2ND AND VIRGINIA

RESPONSE TO LPB PRIORITIES 21

LPB PRIORITIES

MEETINGS RECAP

ARC Meeting 1 / June 29, 2018

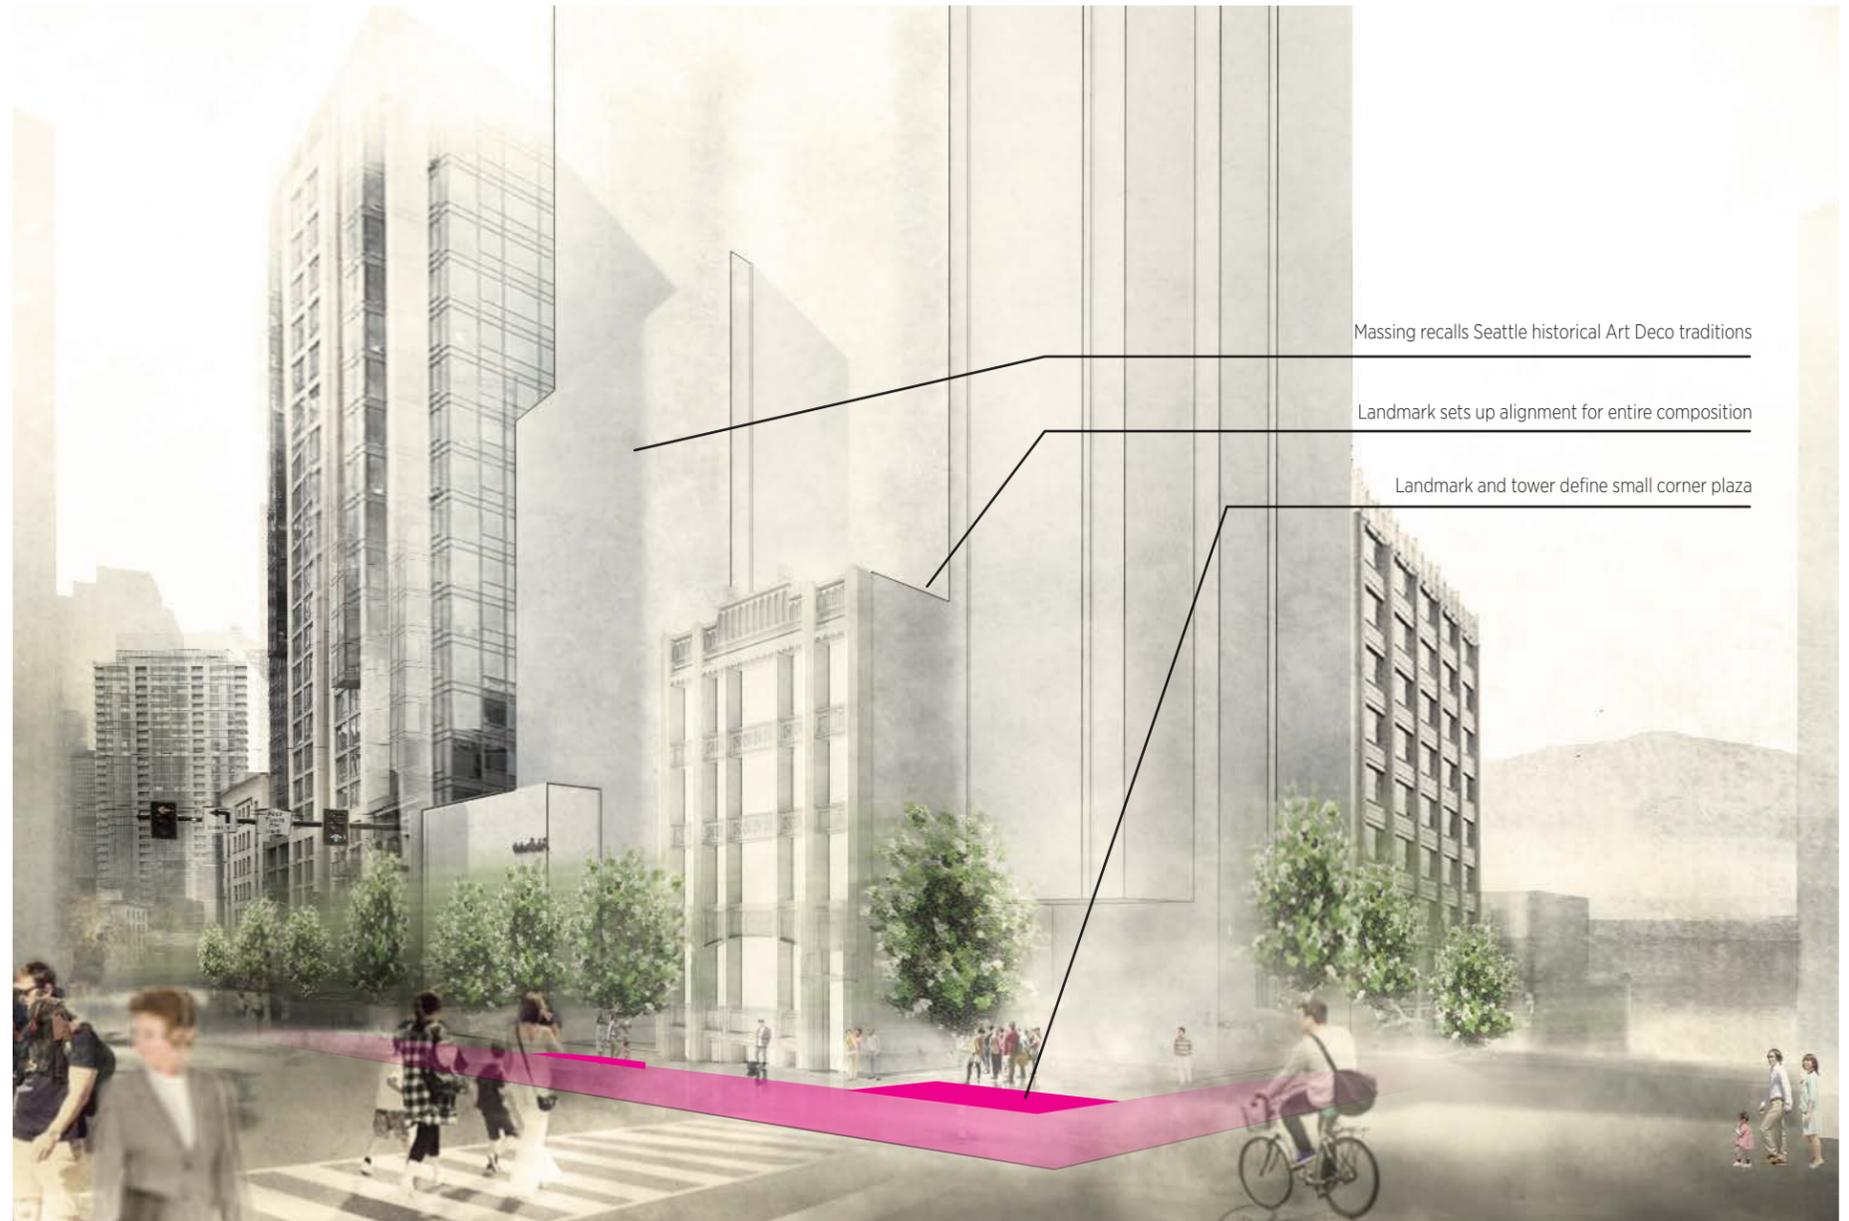
- 1** **Massing:**
Main argument is how this is an improvement beyond 2015, what are we doing beyond that
- 2** **Terminal Sales Annex Volume Expression:**
Imply the sense of the building in the function of the space
- 3** **Existing Floor Levels**
Elevation is more about elevation at windows, need to look at ways to keep floor level
- 4** **Integration of Hotel Clare Comments:**
Outdoor Corner is a step forward in exposing the landmark Study Relationship at the Ground
- 5** **Architectural Style:**
Appreciates the reference to art deco massing and embracing what came before"
References to Northern Life Tower is pleasing, sculpting at the top of tower reflects some of these qualities

ARC Meeting 2 / August 31, 2018

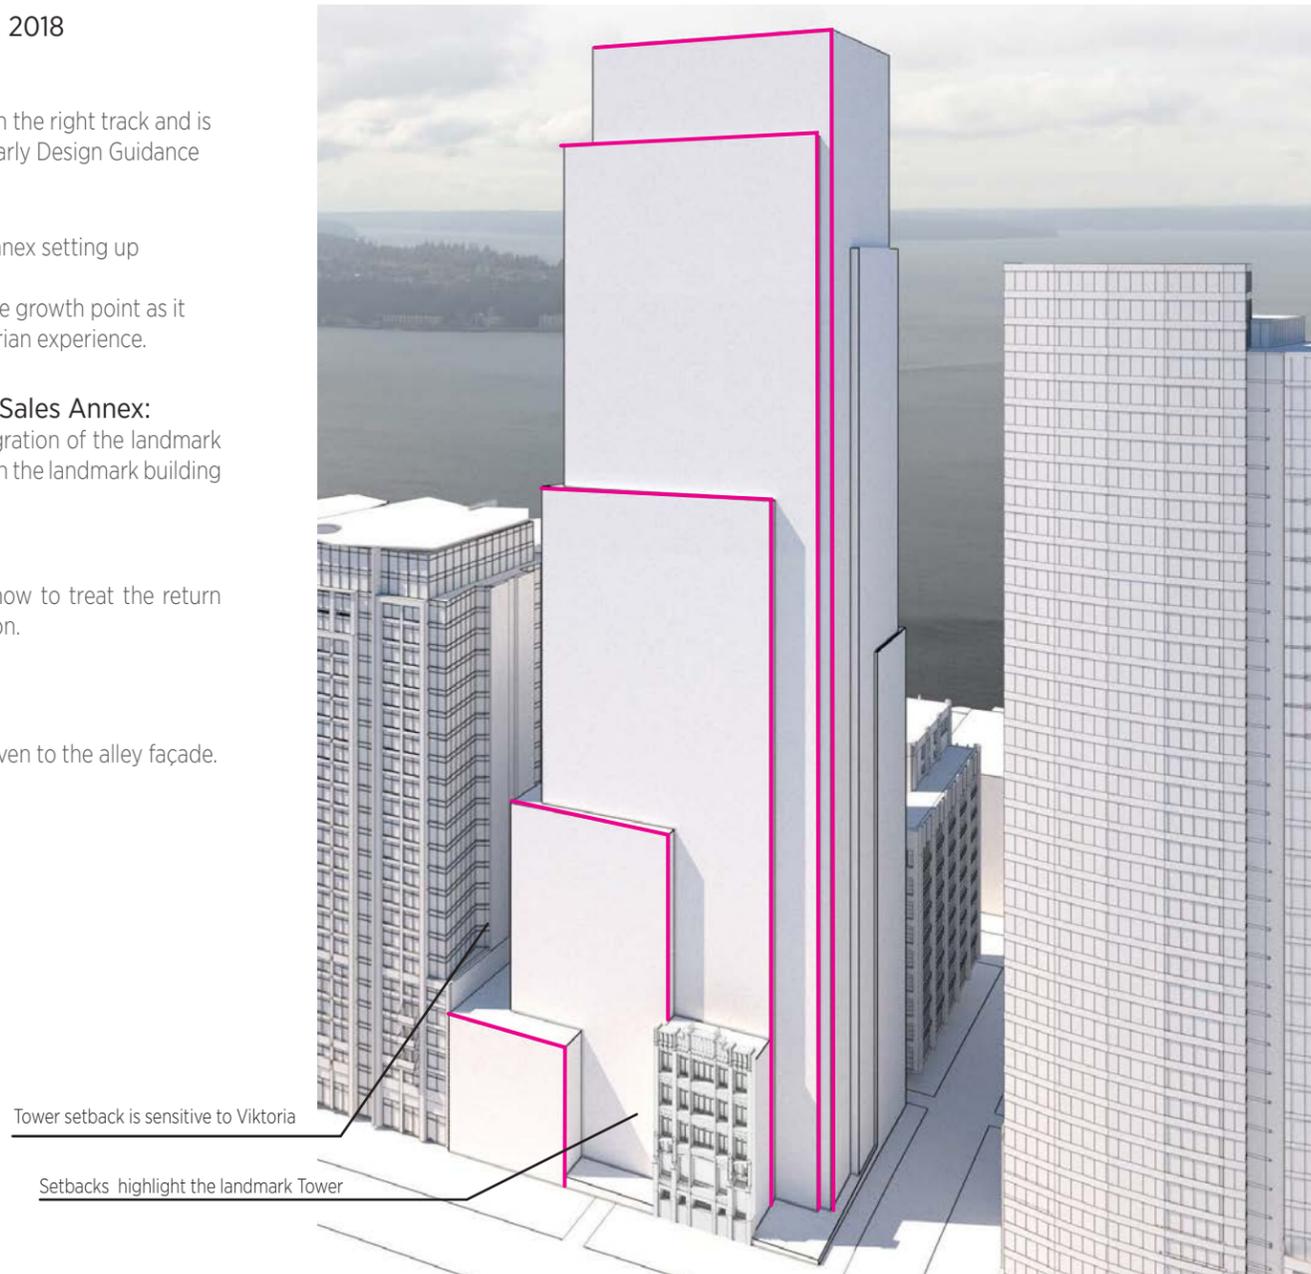
- 1 **Massing:**
Believes the massing concept is on the right track and is appropriate to move forward to Early Design Guidance
- 2 **Vertical Alignment:**
Appreciates the Terminal Sales Annex setting up alignments of the tower above
Applauds approach for it being the growth point as it relates to the ground level pedestrian experience.
- 3 **Integration of the Terminal Sales Annex:**
Intrigued by the experiential integration of the landmark building. Recommend starting with the landmark building as the "seed" for the massing.
- 4 **Party Walls:**
Recommends the team explore how to treat the return party walls. Consider art installation.
Openings need more exploration.
- 5 **Alley Façade:**
Would like to see consideration given to the alley façade.

ARC Meeting 4 / February 14, 2020

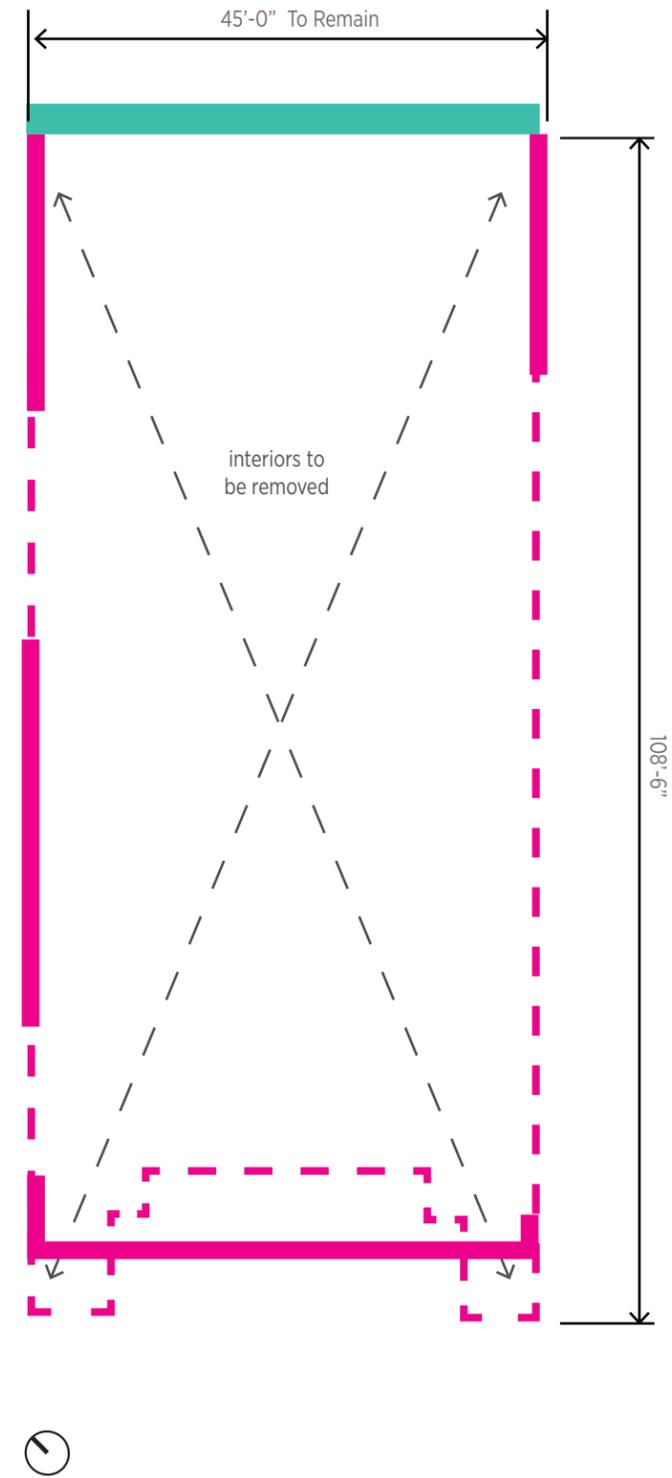
- 1 Party Wall:**
Options for regularized fenestration were requested.
- 2 Party Wall:**
Mural should be relevant to downtown.
- 3 Landmark Volume Expression:**
Show legibility of the landmarked volume through the proposed building at both the exterior and interior.
- 4 Next Step:**
ARC indicated the next step is to brief the full Board.

ARC Meeting 6/ August 25, 2023

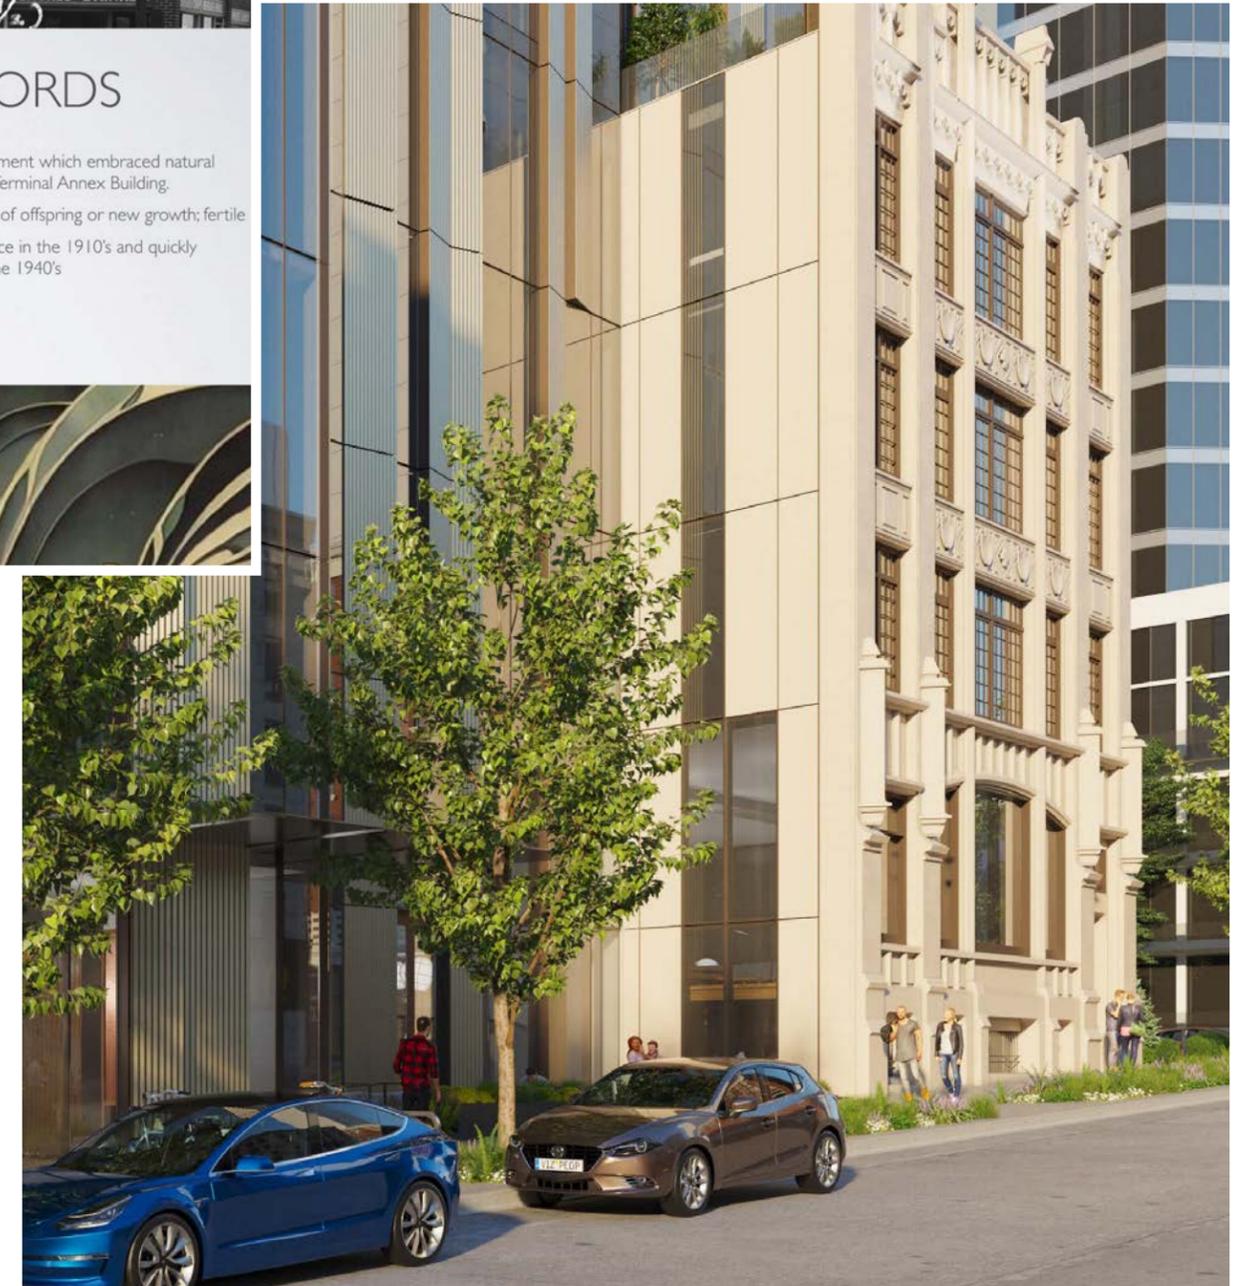
- 1 Project Re-Introduction:**
Team reviewed and re-introduced the project since the brand change and redesign.
- 2 Existing Levels:**
Team addressed the minor changes in existing TSA levels to proposed project levels.
- 3 Active Uses in the TSA:**
Changed from previous design to host guestrooms at upper levels, and hotel lobby and grand stair at lower.
- 4 Langham Re-Branding / Art Program Curation:**
Contextual proposal for the art program / mural artist direction.
- 5 Next Step:**
Following ARC planned to review technical details.

ARC Meeting 7 / October 27, 2023

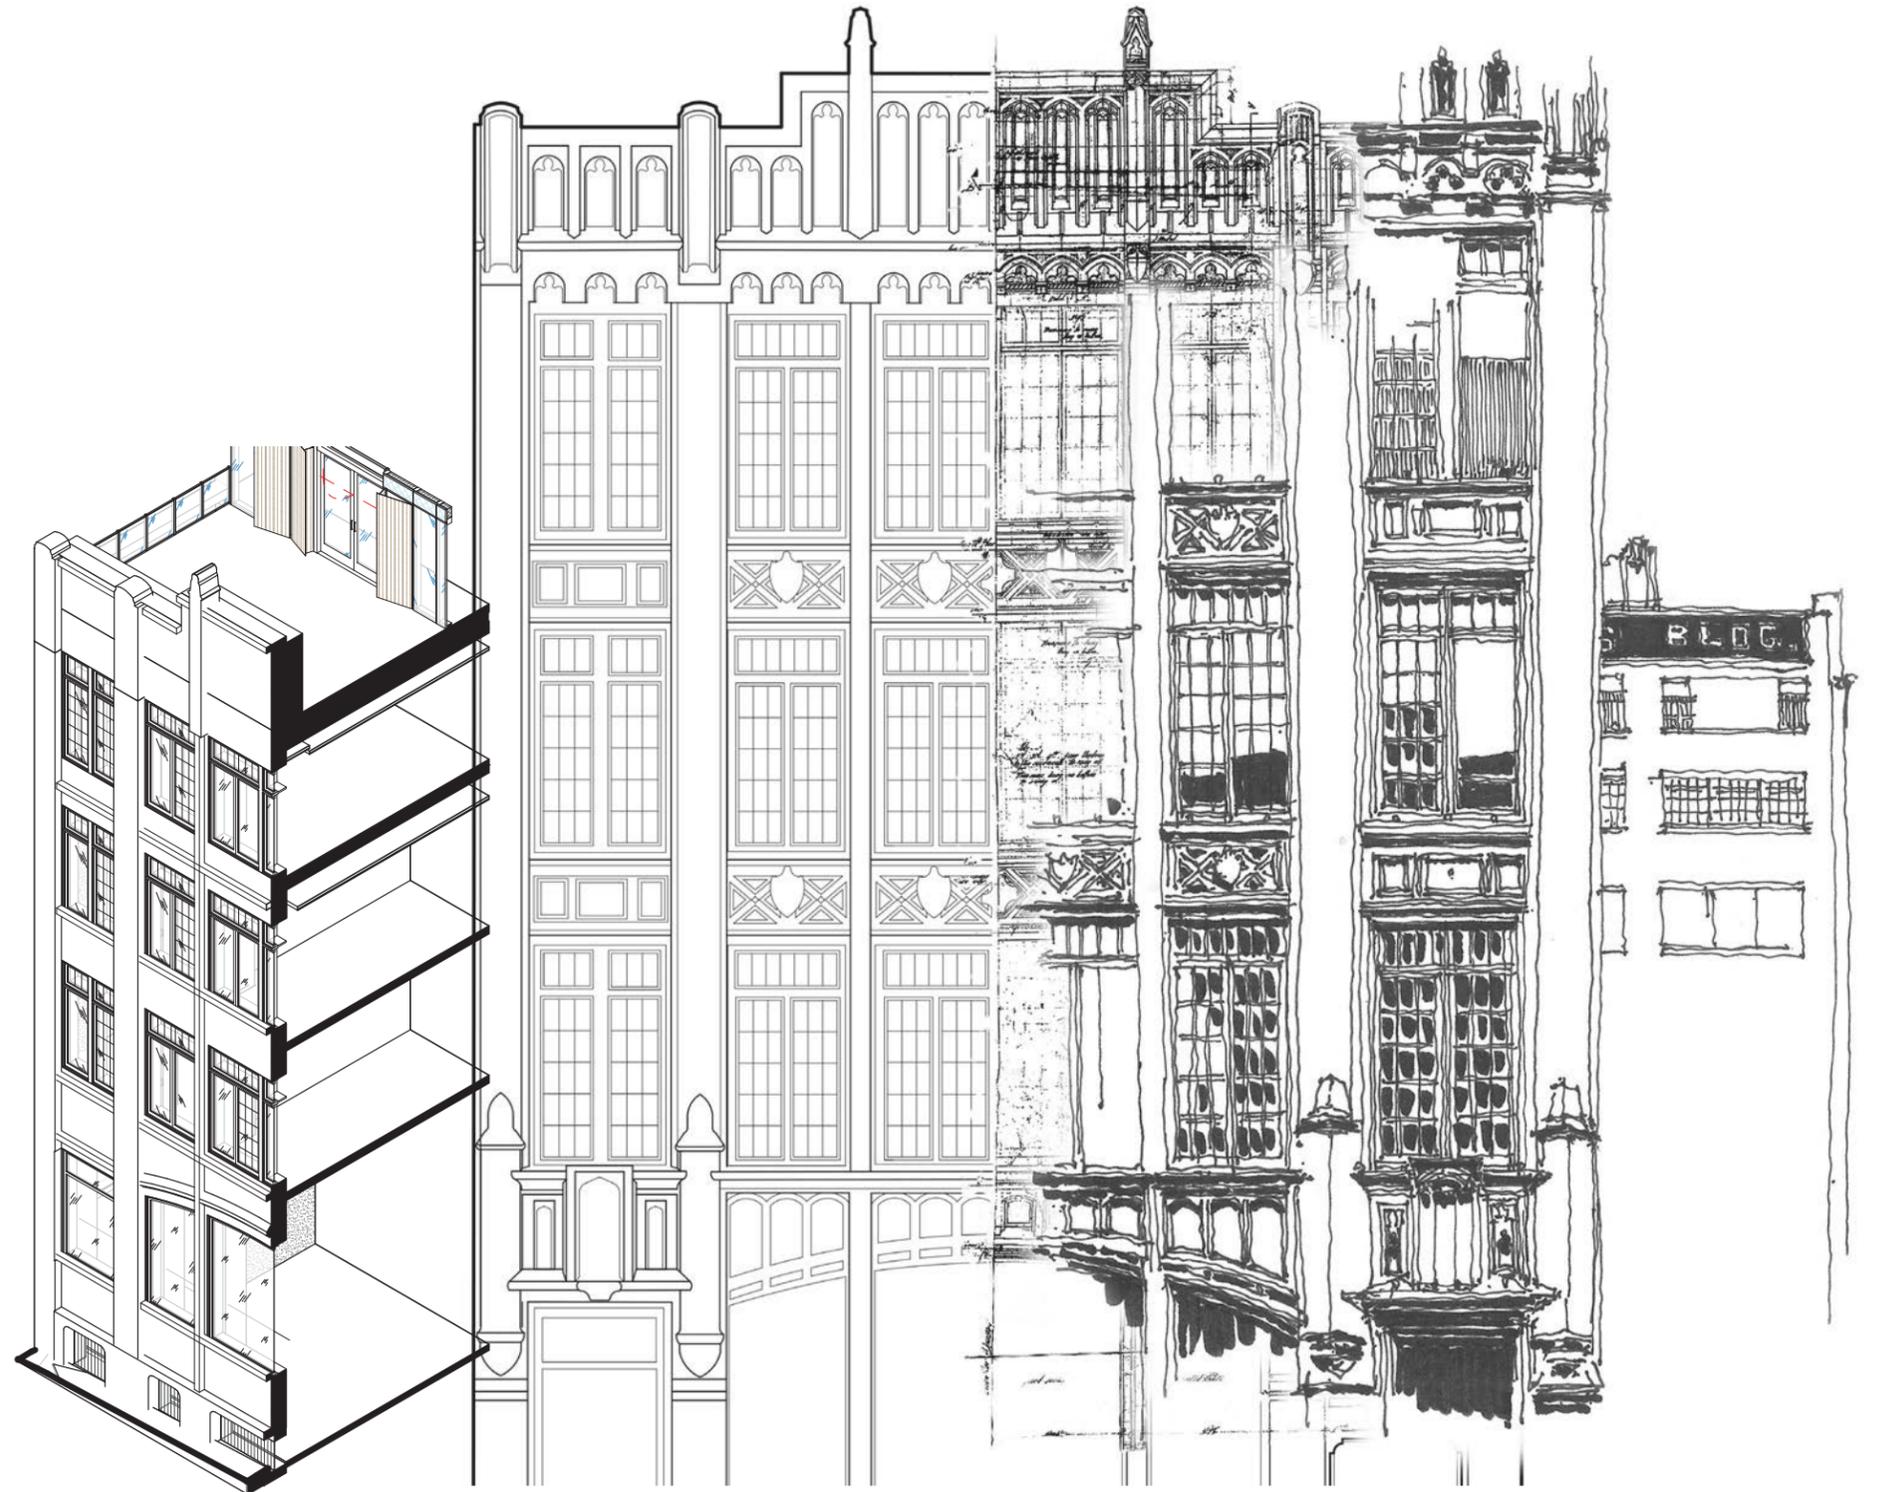
- 1** **TSA Party Wall & Window Concept:**
Team responded to ARC comments and re-articulated the glazing on party walls.
- 2** **Facade Restoration:**
Pioneer Masonry reviewed process for the TSA terracotta restoration and rehabilitation.
- 3** **Temporary and Permanent Facade Bracing:**
Team reviewed the structural temporary and permanent TSA facade bracing.
- 4** **Architectural Details:**
Team reviewed and explained all architectural detailing that relates to the TSA.
- 5** **Next Step:**
ARC indicated the next step is to brief the full Board.
